Date Issued :	June 21, 2022	PCN Number :	512072
Reason for Change :	Change Supplier		
Description of Change :	This notification is to inform you about change of supplier impacting the part(s) attached as per list, No changes will be made to product as part of this change		
Reason for Short Notice :	Special Request		
Assessment of Change :	Reliability Test Report/s		
Planned Implementation Date :	September 30, 2022		
Sample Availability Date:	September 25, 2022		
Internal Molex Qualification Date :	September 25, 2022		
Last date to request Samples by Customer :	September 30, 2022		
Traceability Code Markings / Date :	Date code

Product Series: 47306xxxx

Metal Post series: 67800xxxx

Product Picture

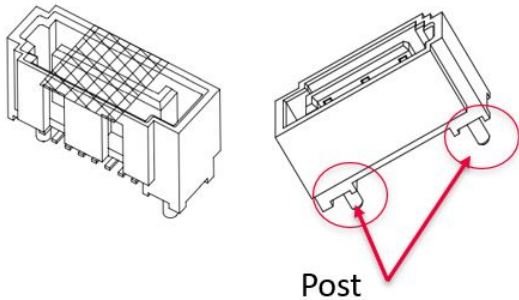
Add post alternative copper materials
"HBI59"

Before	After
1. MATERIAL: LOW LEAD BRASS C6802.	1. MATERIAL: a. LOW LEAD BRASS C6802 b. LOW LEAD BRASS HBI59. (F2)

- **Add alternative copper materials "Hbi59".**
